PŘÍKAZ K ZACHOVÁNÍ LETOVÉ ZPŮSOBILOSTI

Číslo: CAA-AD-1-025/98

KLUZÁK - RYCHLOSPOJKY ŘÍZENÍ - ÚPRAVA

**Airworthiness
Directive
1994-001/2**

Section II

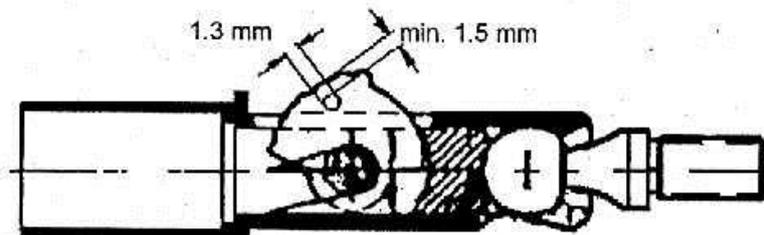
Drill the hole \varnothing 1.3 mm with the ball correctly inserted so that one edge of the hole is level with the main body of the connector and on the other side at least 1.5 mm of material is left (see also the following sketch).

When working on the connector, please see to it that no borings get in between the ball and the socket.

Section III

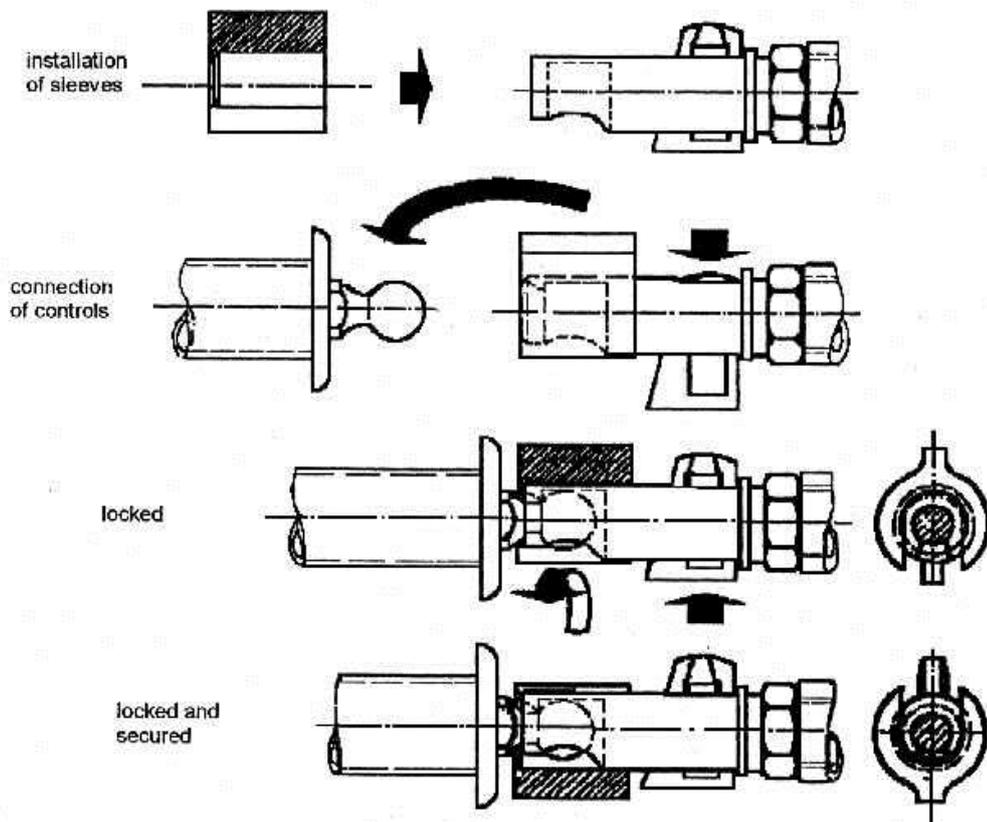
For installation, the sleeves have to be slid axially onto the L'Hotellier ball and socket connectors.

They may by no means be clipped radially onto the L'Hotellier ball and socket connector. Radial clipping (excessive opening of the sleeve) may lead to cracks or ruptures due to oversteering so that the sleeve cannot function properly any more.

Section I

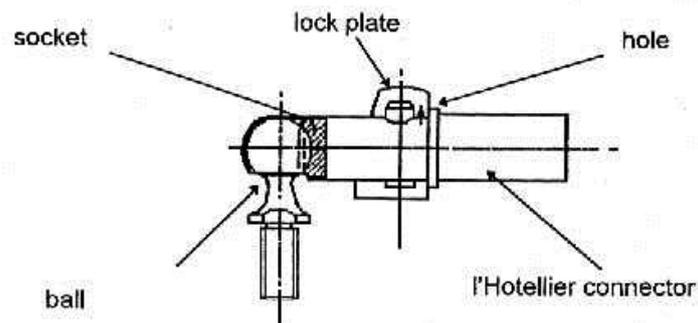
If the connectors are not yet equipped with safety pins (e.g. l'H 140-31 made by Hotellier), these safety pins have to be retrofitted. In certain cases it may become necessary to rebores the hole in the lock plate, which is provided for visual inspection, to $\varnothing 1.2$ mm so that the safety pin can be inserted.

Unsecured ball and socket connectors may open automatically in flight!

Section III

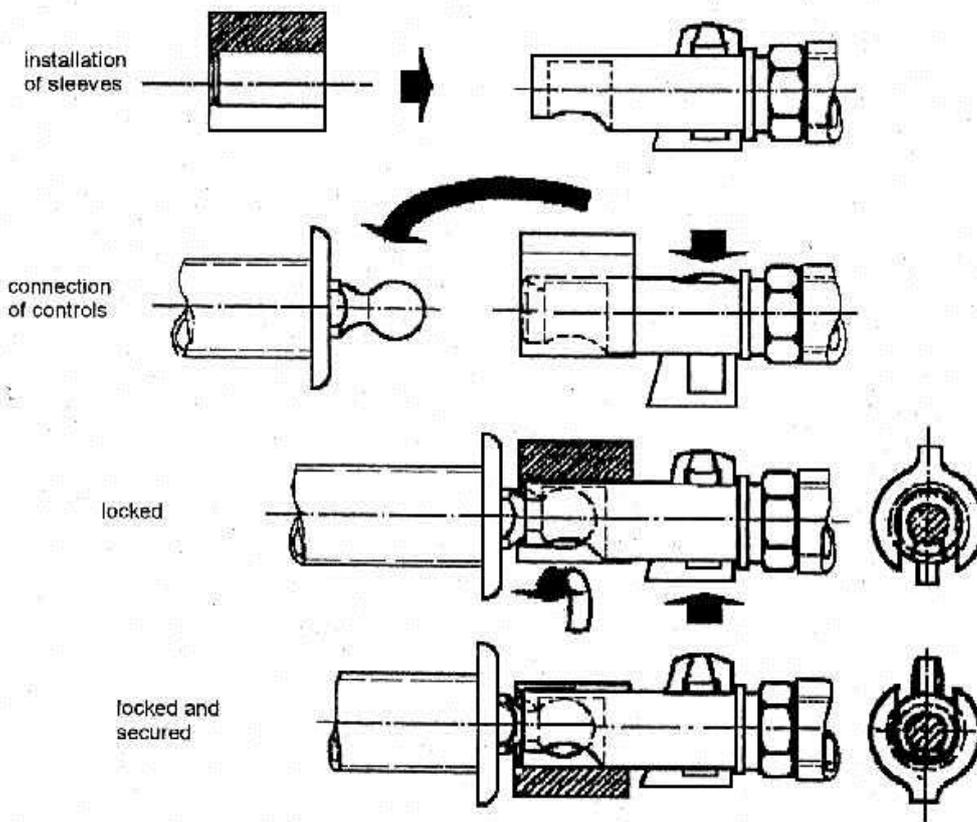
For installation, the sleeves have to be slid axially onto the l'Hotellier ball and socket connectors.

They may by no means be clipped radially onto the l'Hotellier ball and socket connector. Radial clipping (excessive opening of the sleeve) may lead to cracks or ruptures due to overstressing so that the sleeve cannot function properly any more.

Section IV

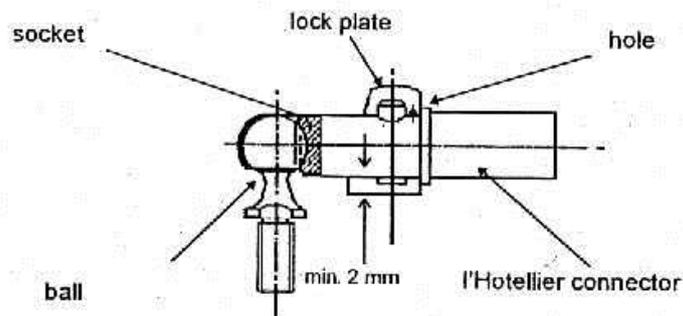
The socket is to be slid completely over the ball with the lock plate pressed down. During locking the lock plate moves back slightly so that in a correct connection the hole on the narrow edge of the lock plate becomes visible.

The safety pin is to be inserted in this hole thus securing the ball and socket connector.

By loading the connection full engagement of the ball is to be verified!
